FED. ROAD DIST. NO.	STATE	PROJ. NO.	FISCAL YEAR	SHEET NO.	TOTAL SHEETS
HAWAII	HAW.	83G-01-03M	2005	ADD. 38	47

**PAVEMENT MARKING
 ϕ SIGNING PLAN**

KAMEHAMEHA HIGHWAY RESURFACING
 Kahiko Street to Pali Highway
 Project No. 83G-01-03M

MOUNTING DETAIL FOR D-1 SIGN

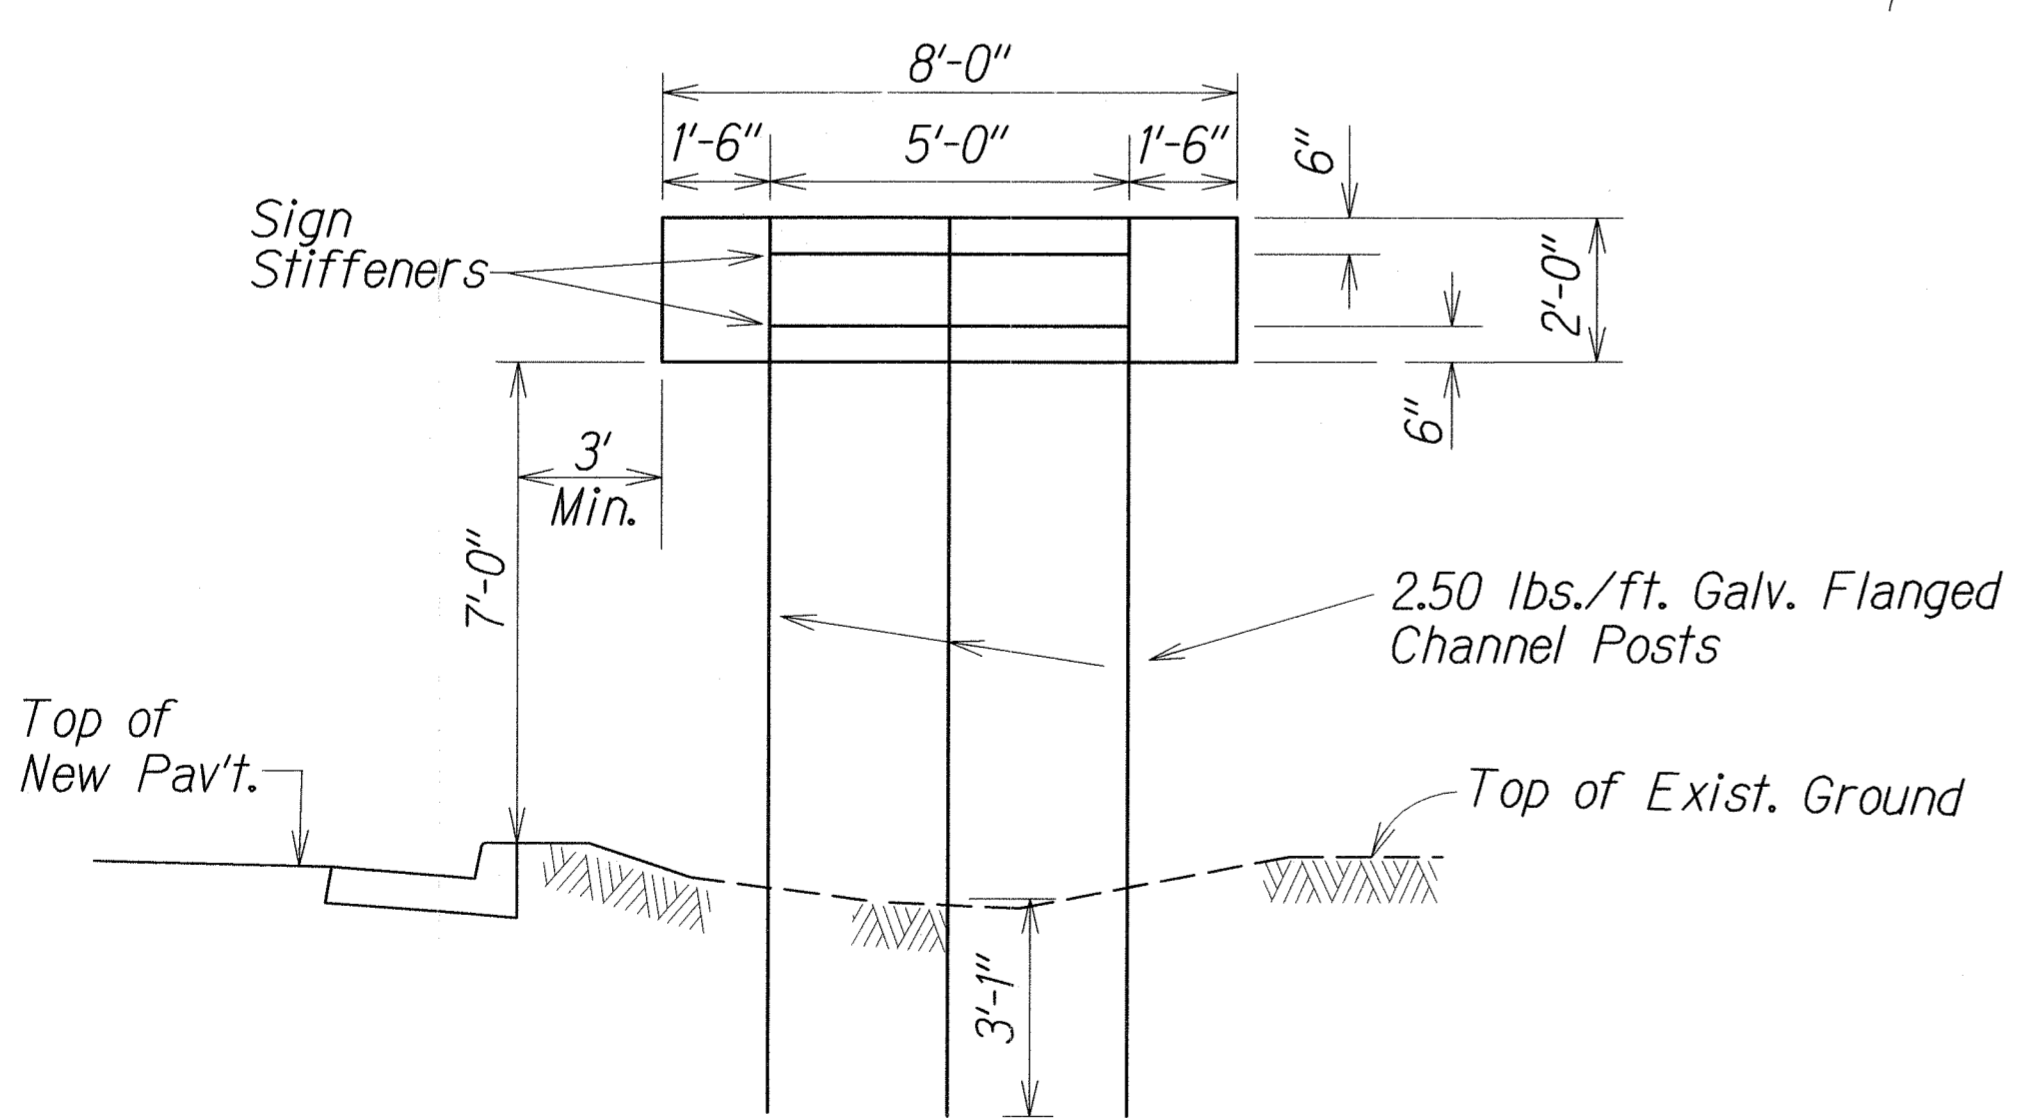
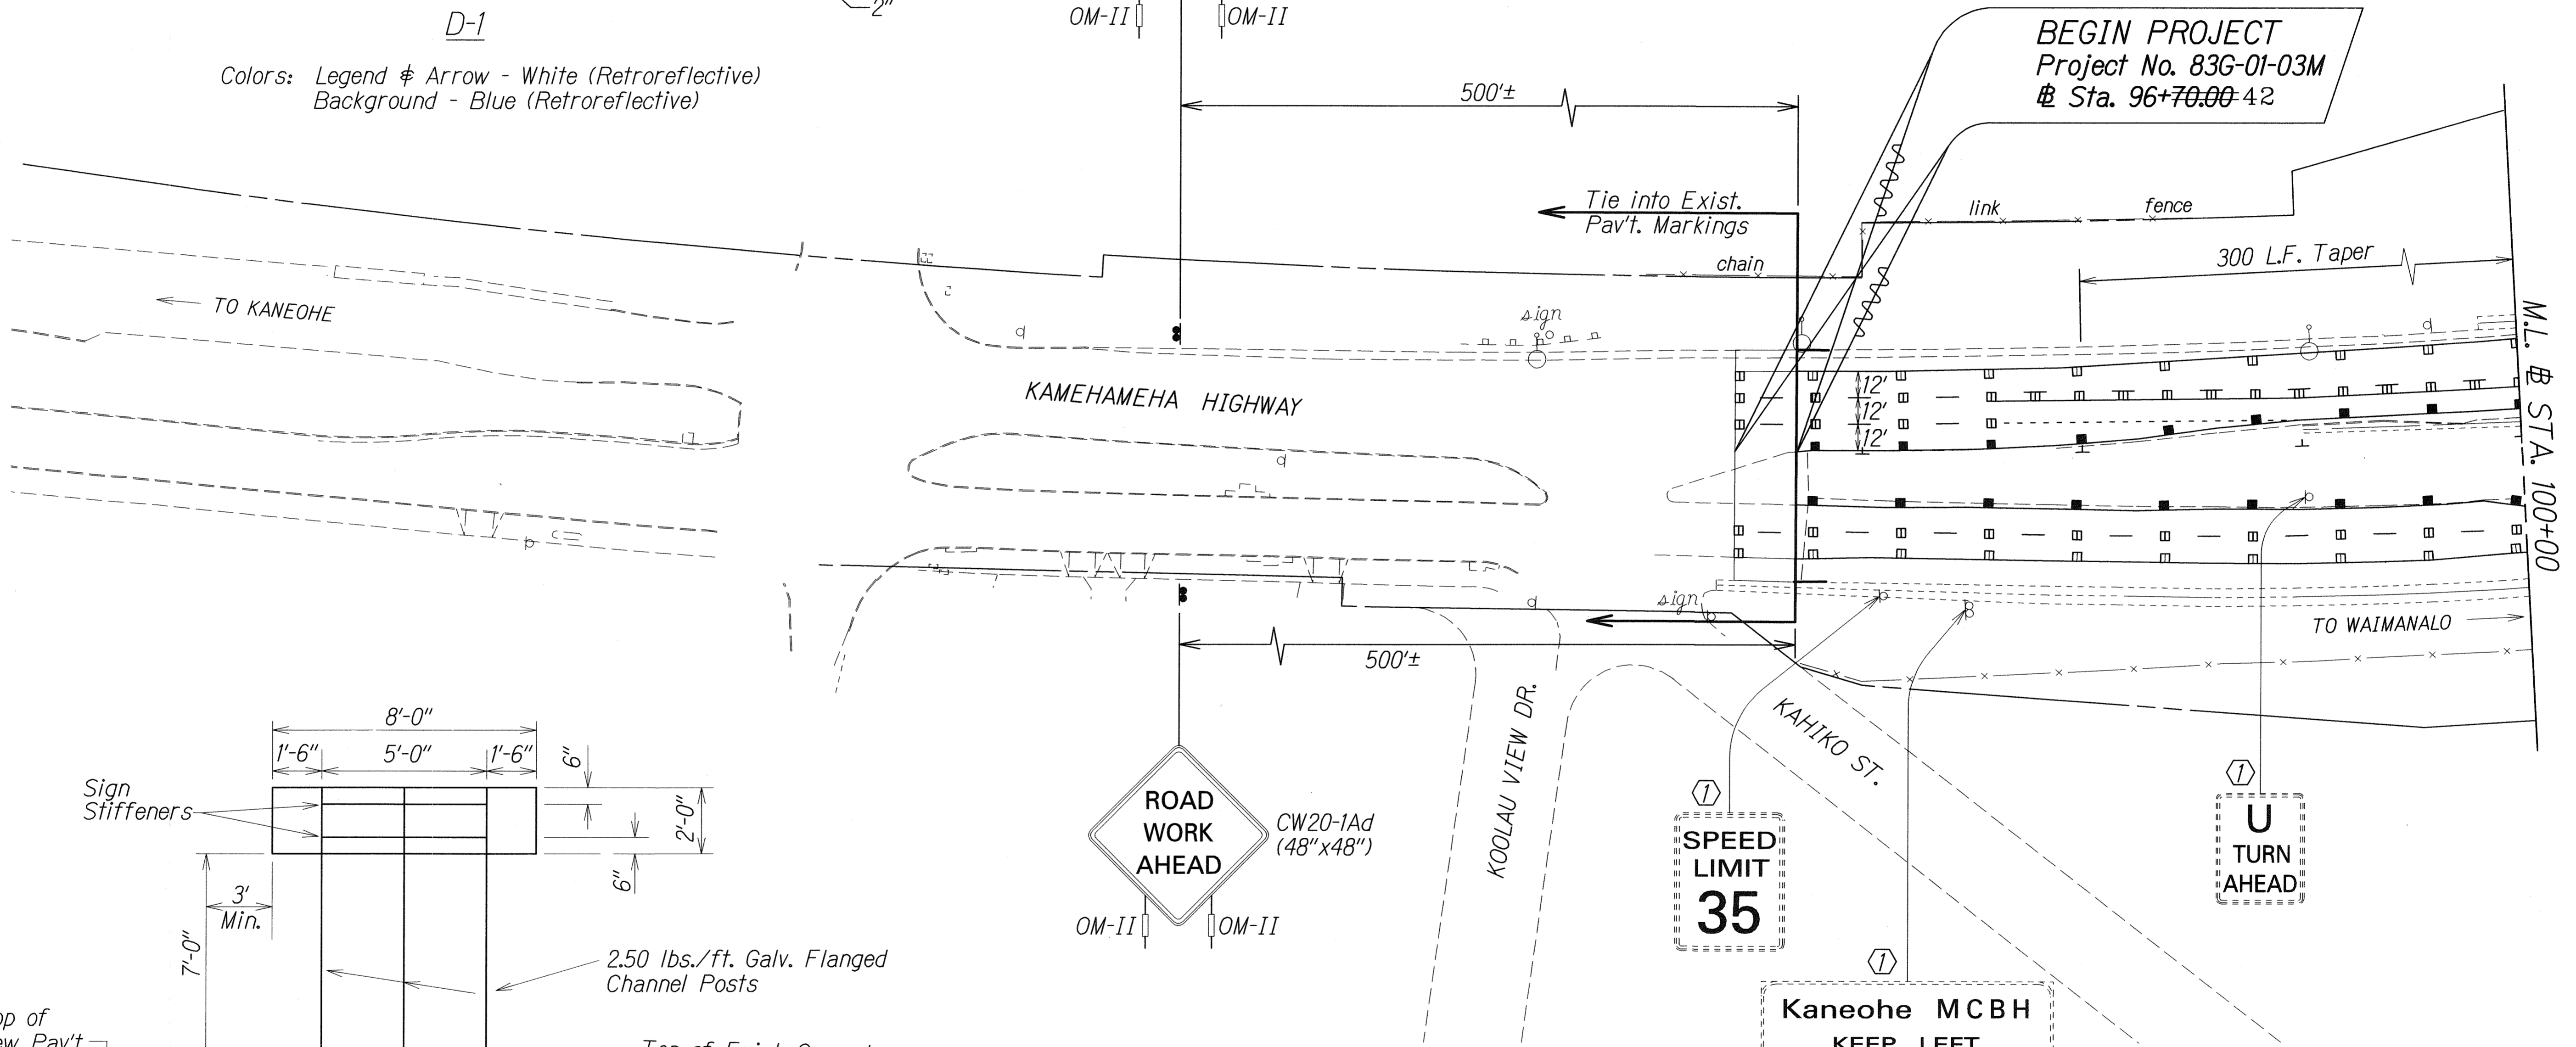
6/17/05	Add construction and destination signs.
DATE	REVISION

KAMEHAMEHA HIGHWAY RESURFACING
Kahiko Street to Pali Highway
Project No. 83G-01-03M
Scale: 1" = 40' Date: Oct. 2004
SHEET No. T5 OF 8 SHEETS

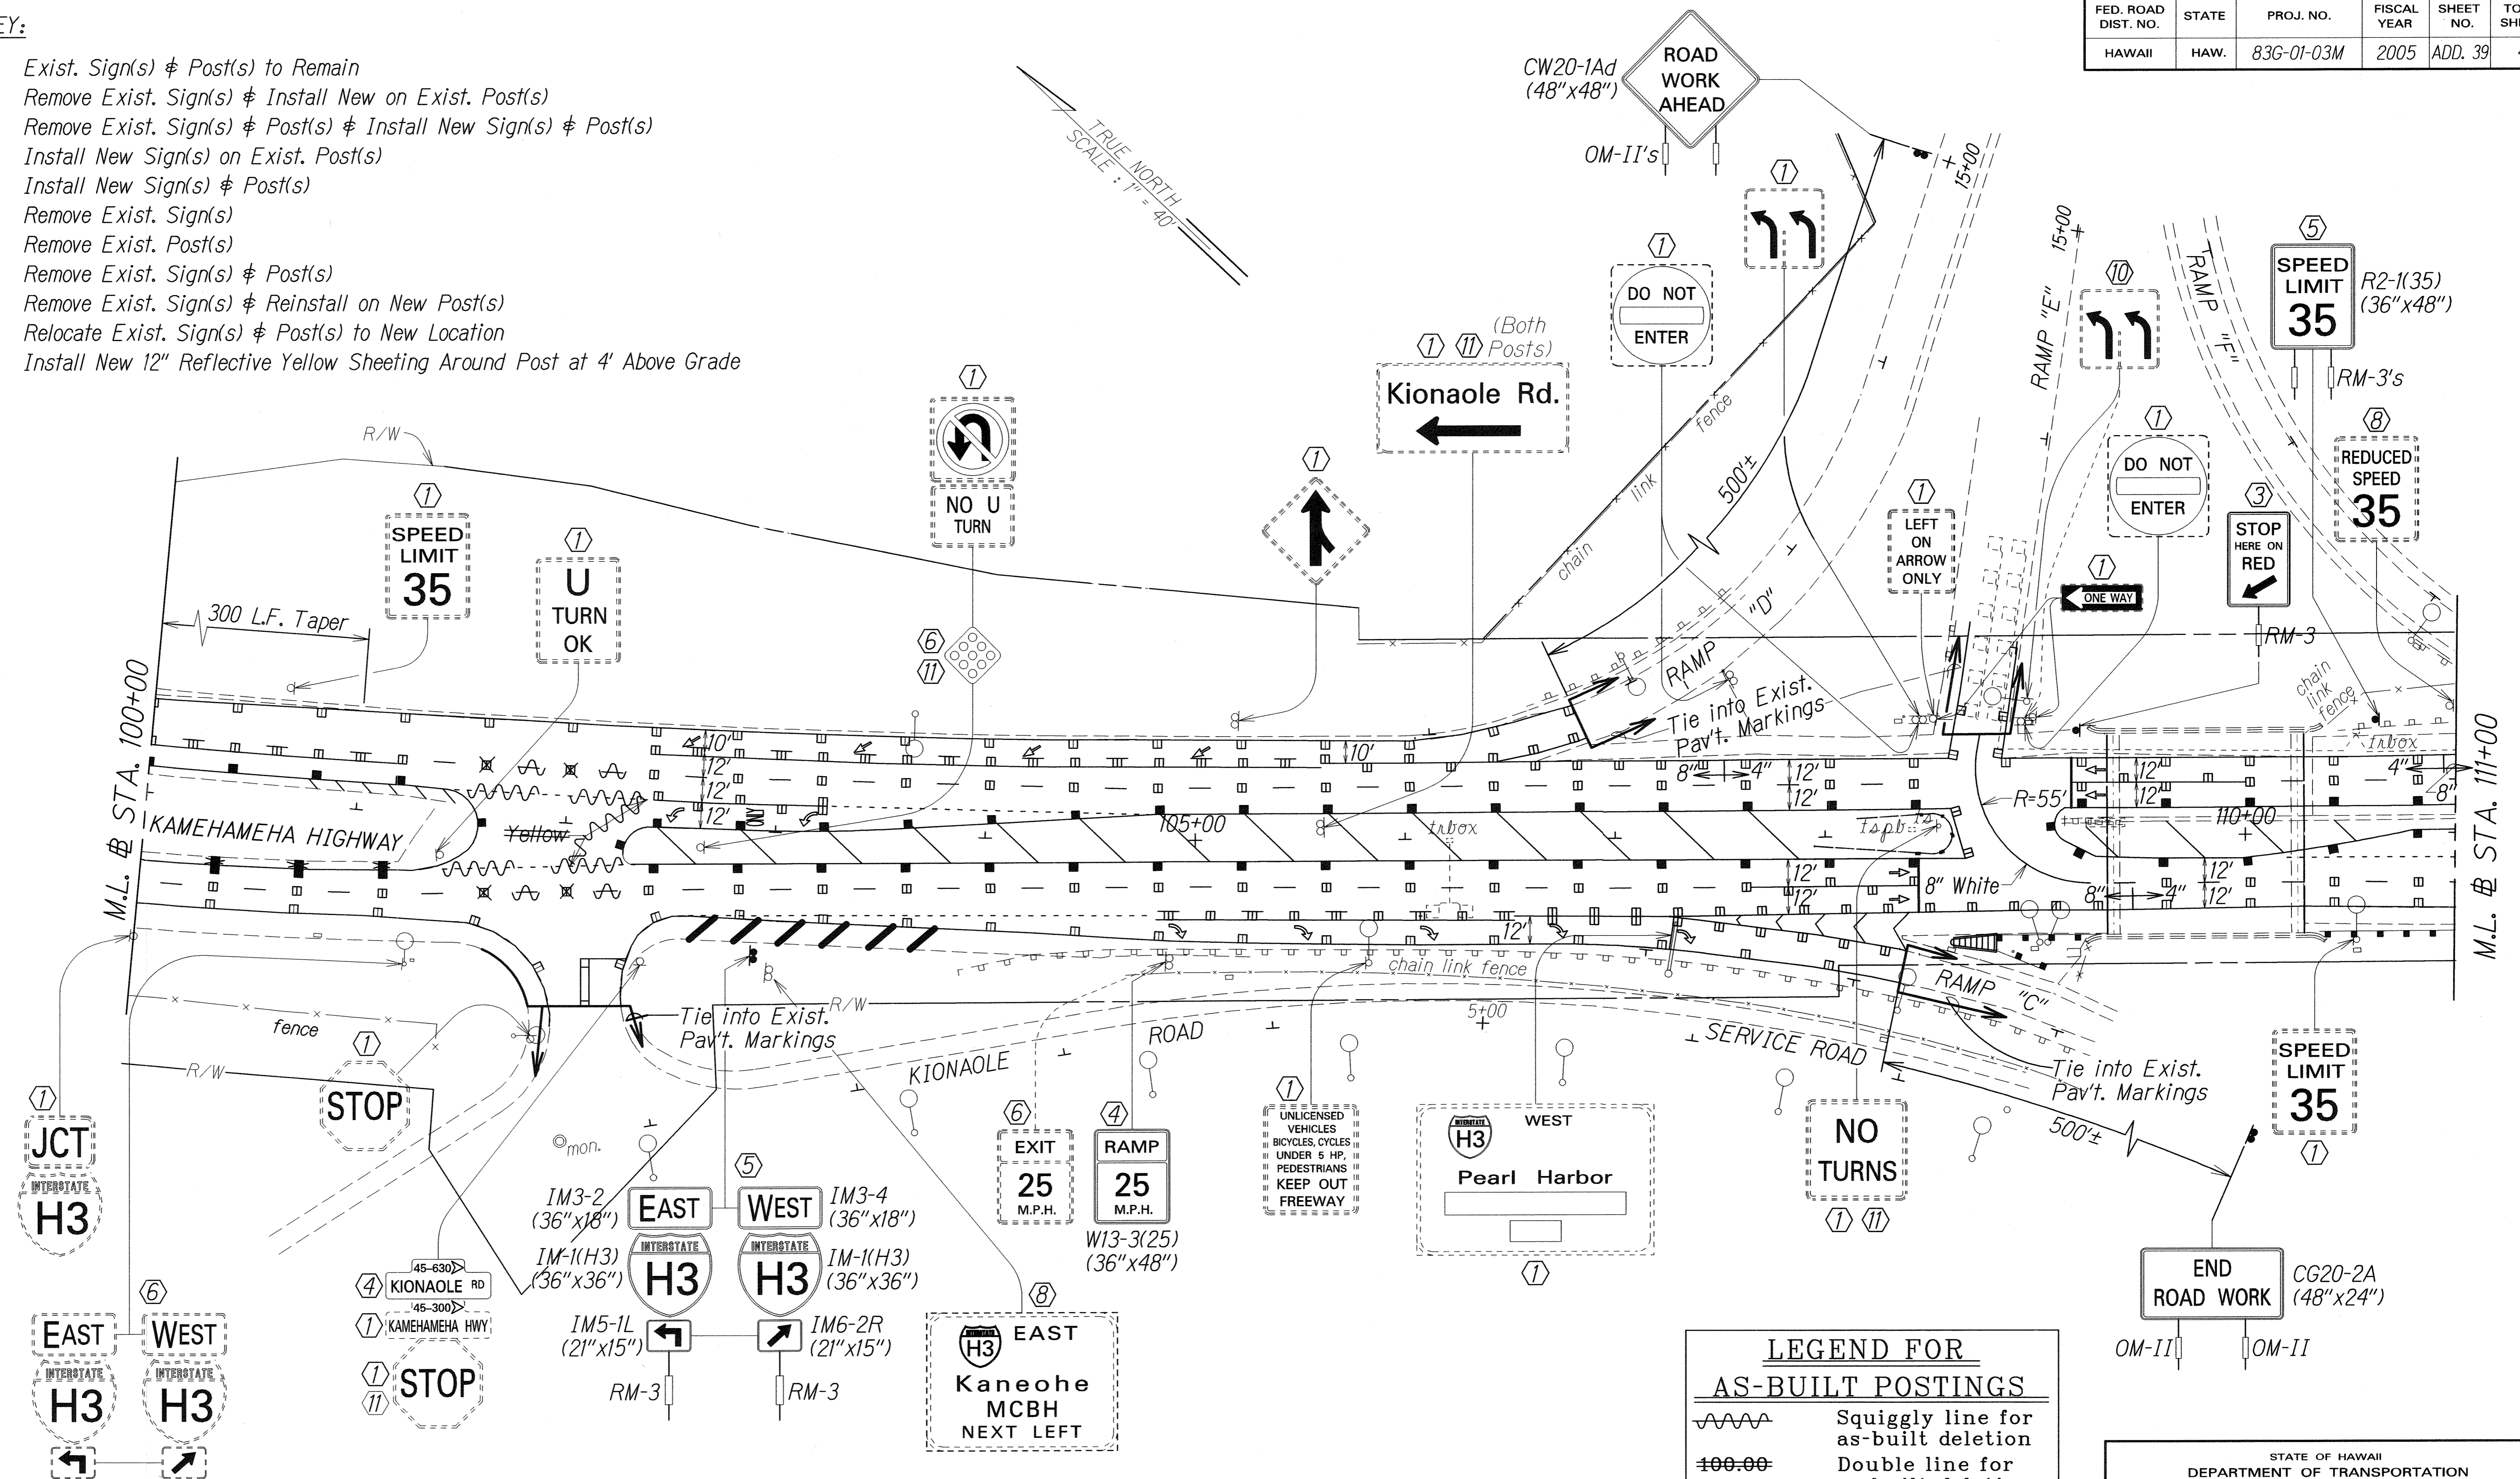
DATE	REVISION
6/17/05	Revise and add signs.
